35 Greville Road  
London NW6 5JB

Basement Impact Assessment  
Audit

For  
London Borough of Camden

Project Number: 12066-62  
Revision: F1

Section:  
Sheet: GMA-2  
Rev:

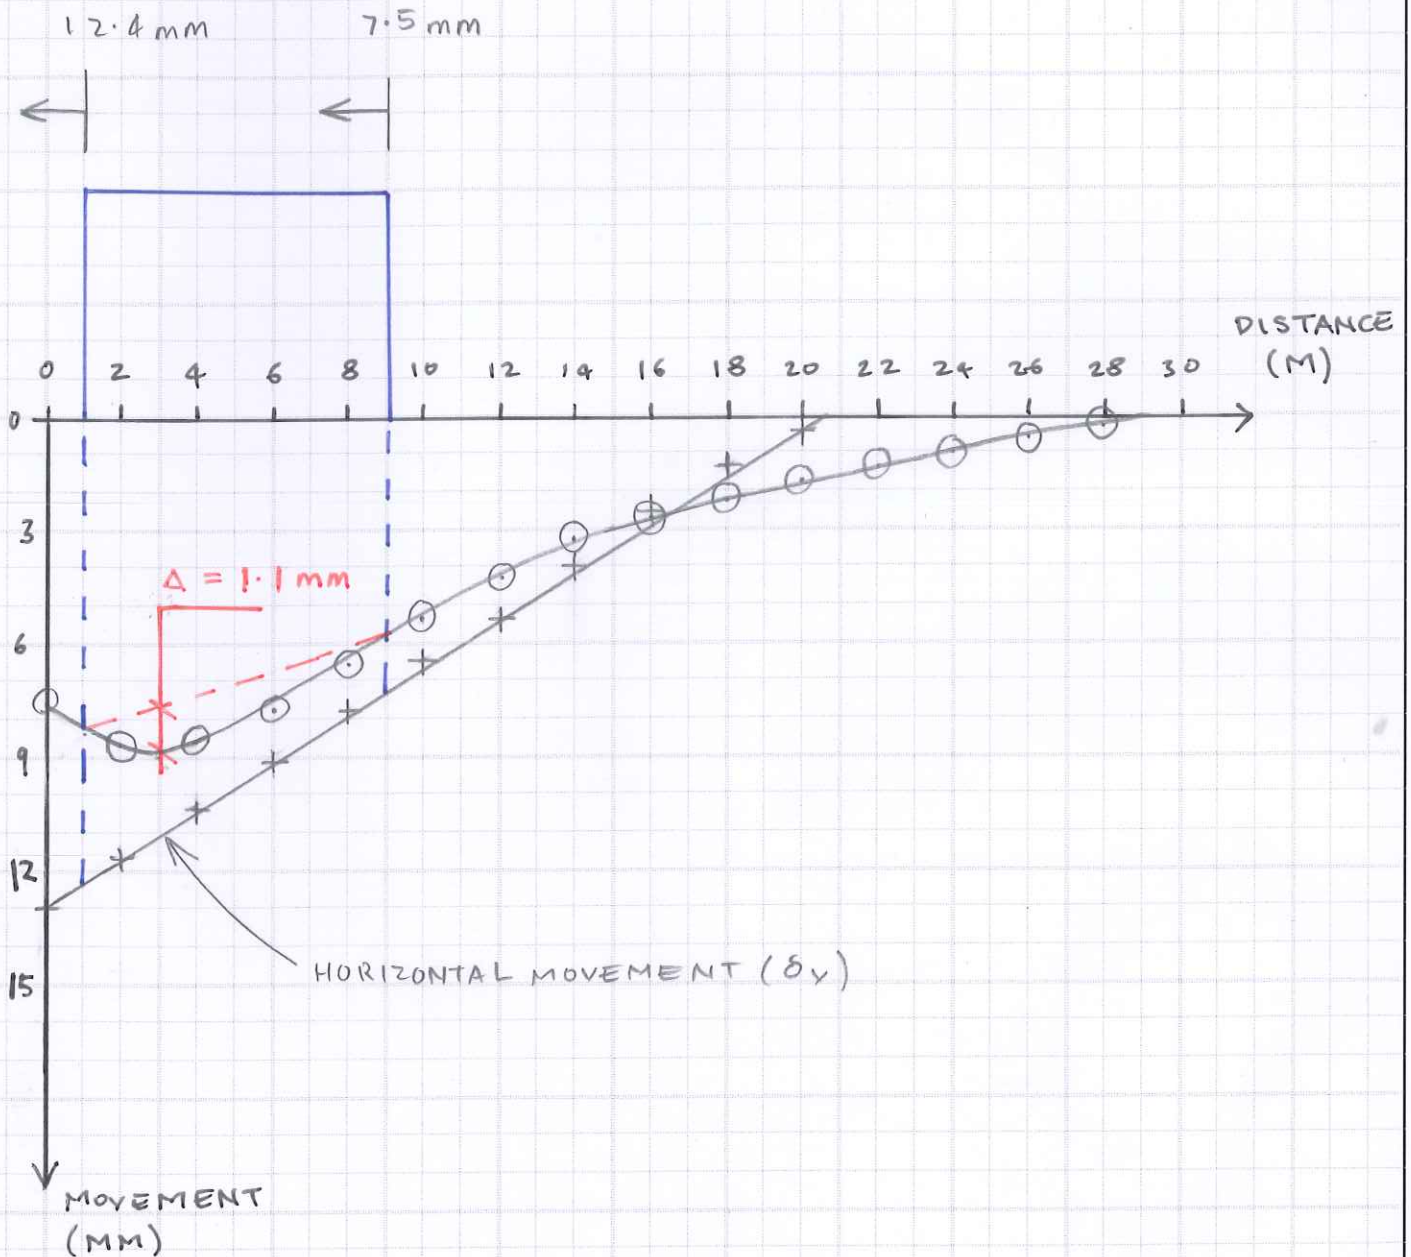
- 4.13. Subsequent to the second audit, Croft have undertaken a GMA (see Appendix 3) which assumes a wall depth of 14.40m with a maximum excavation depth of 4.80m. Category 1 (Very Slight) damage is now predicted for No 37 which means further mitigation measures are no longer required. This is accepted.

- 5.12. The Ground Movement Assessment (GMA) was revised following the initial audit and Category 2 (Slight) damage was predicted. This requires mitigation measures and the impacts to be re-evaluated and additional props to increase wall stiffness were proposed by Croft. Increasing the amount of propping was considered unfeasible as it exacerbated the problem of limited room for construction. It was suggested that the GMA be considered in more detail to provide a more accurate prediction of likely damage.

The ground movement analysis has been revised. Please find this attached (this now supersedes the analysis given in Section 8 of the Land Stability BIA, which was submitted previously). The revised ground movement analysis shows that the maximum damage category is 1. Additional mitigation measures are no longer required now that we are not exceeding category 1.

Max Anticipated Damage may be categorised as **'Very Slight' ; Category 1**
